July 07, 2022

This Addendum to the Invitation for Bid (IFB) serves to notify all interested bidders of clarifications and or changes to IFB No. P22002, and becomes part of this IFB. Proposers are required to acknowledge receipt of this addendum in their bid. If not acknowledged, Proposers' bid may be considered "non-responsive."

Elderly Development - Fresno Housing Authority  
 2415 5th St  
 Sanger, CA 93657

# Floorplan

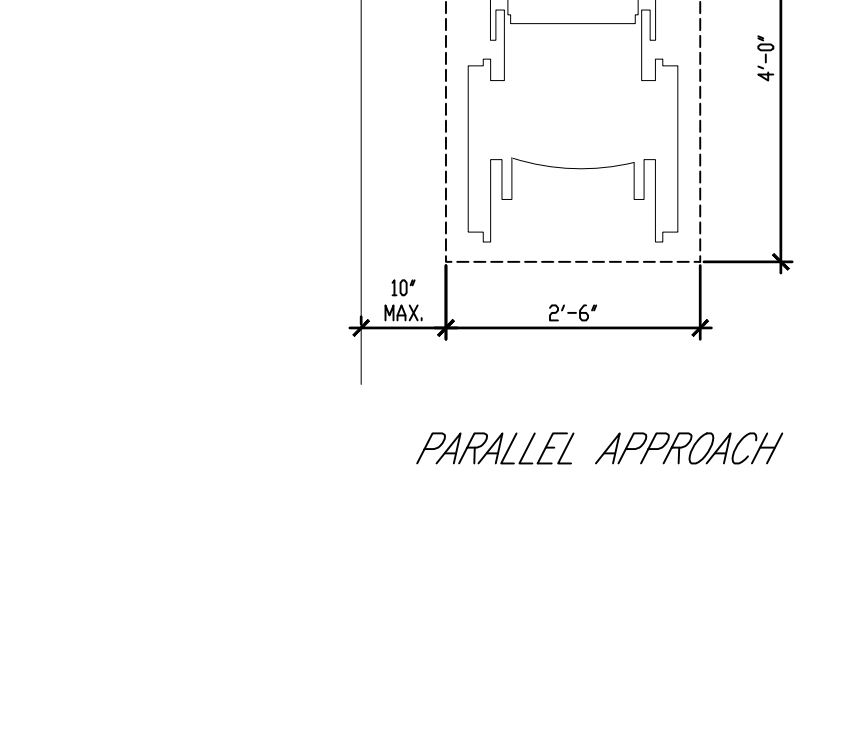
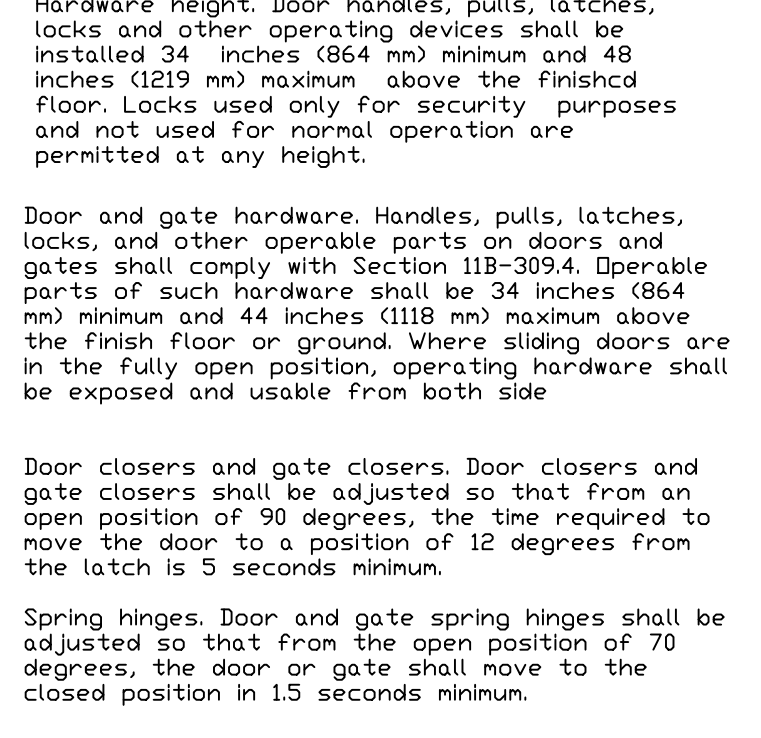
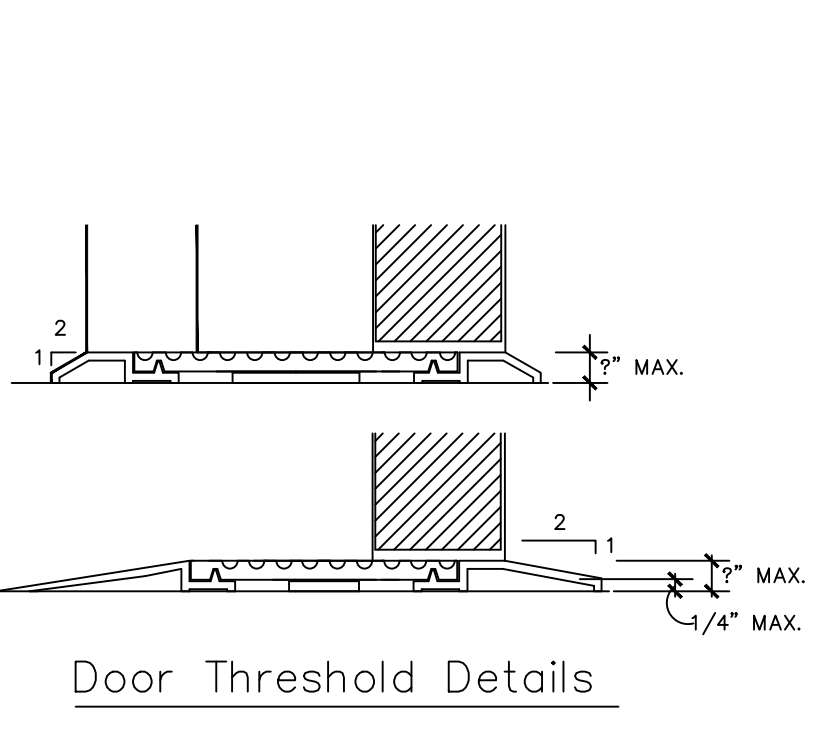
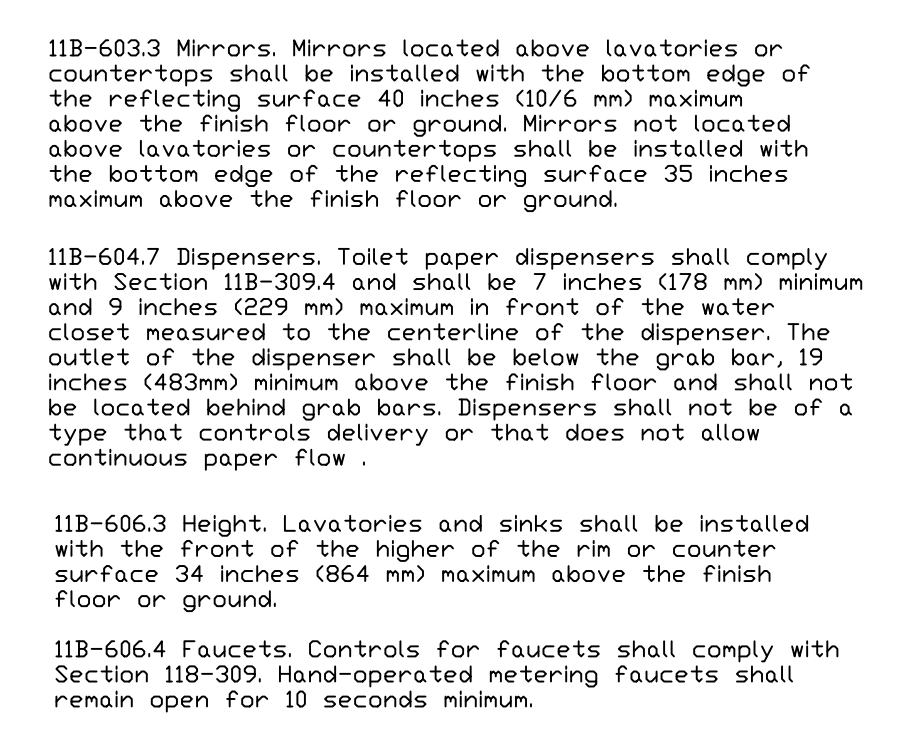
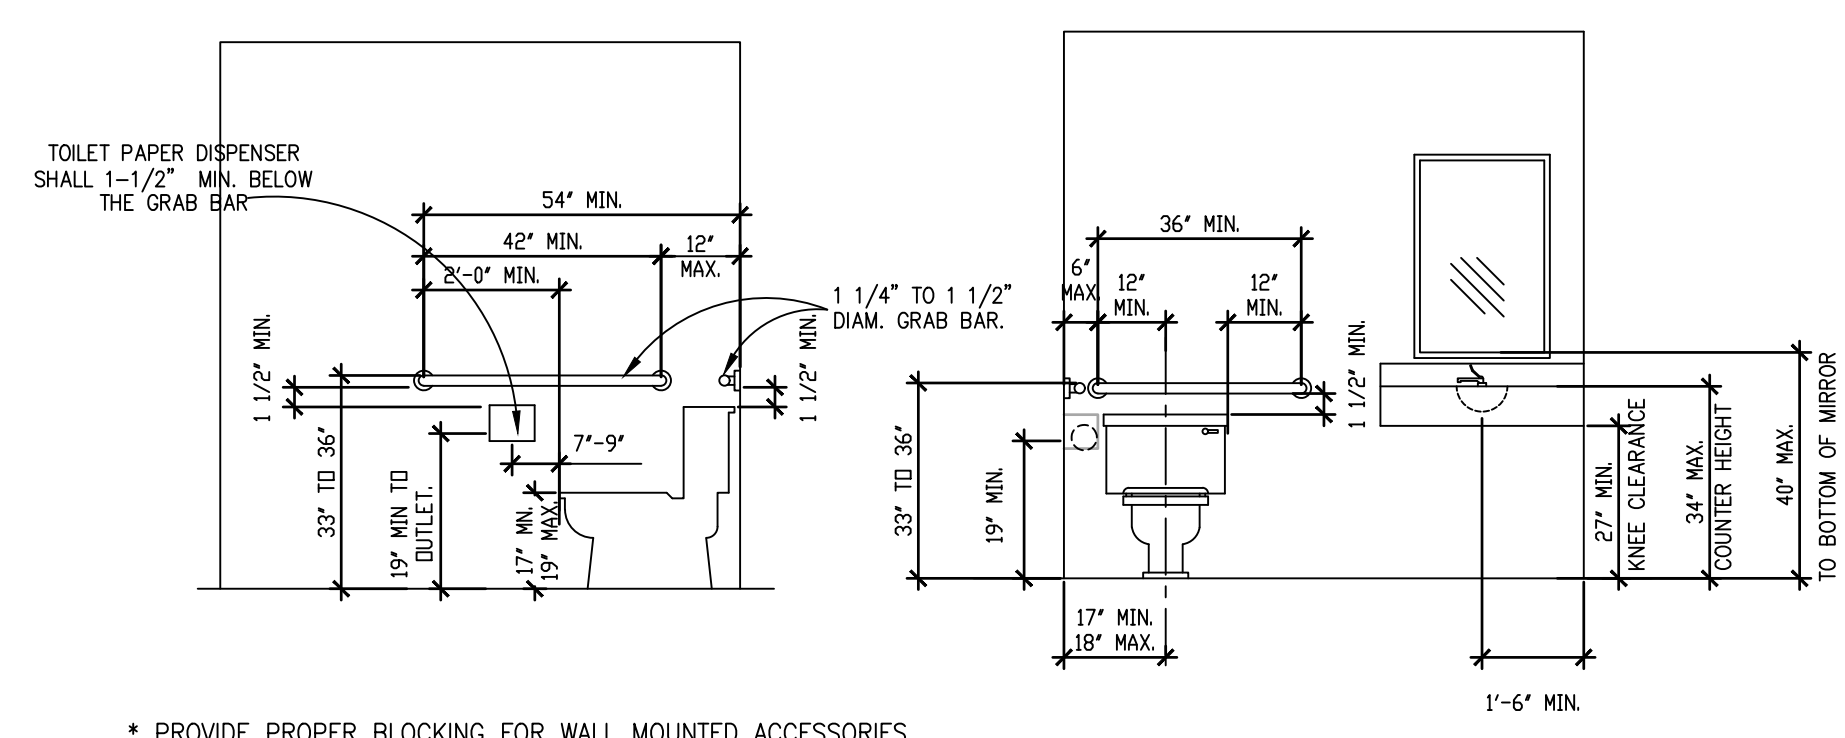
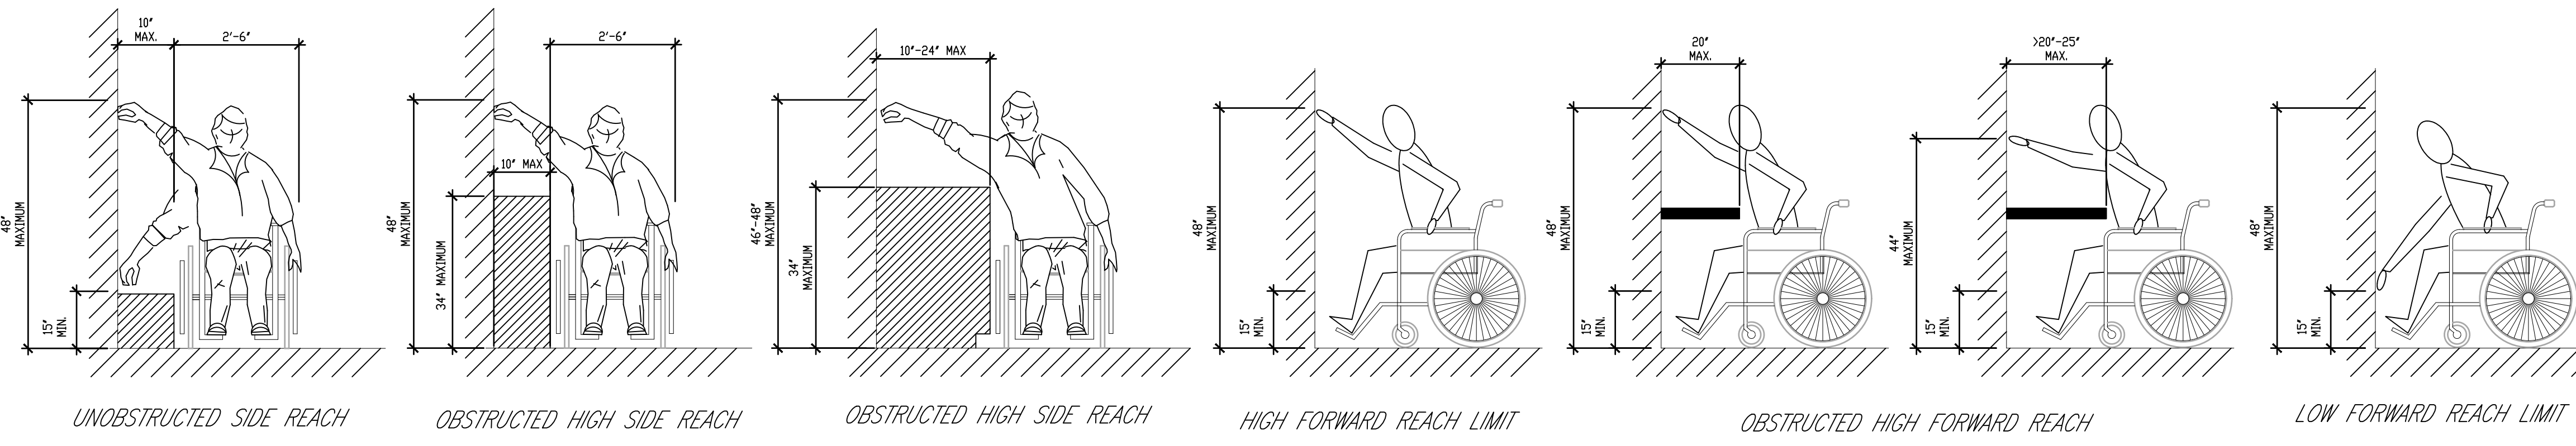
- Relocate toilet from facing shower to facing bathroom door/lav.
  - Maintain ADA clearance from side wall shower and lav.
  - Replace existing toilet with new accessible Kohler Elliston Complete toilet Elongated bowl model #12767-0. Include new ss water supply line and ¼ turn angle stop.

- Replace existing shower with new accessible shower Freedom 5pc 32-62 with water retention package includes (curtain rod shower curtain weight 33 x grab bars and reversible folding seat, mixing valve and hand-held shower package) ADA/Special Needs modifying drain or supply plumbing as needed.

- Install 12x24 porcelain tile Della Torre Belmont multi-color with 1/8" un-sanded grout with sealer (Agency to select color on floor of bathroom) and 6" wall base from the same tile and same tile under cabinet toe kicks, if applicable.
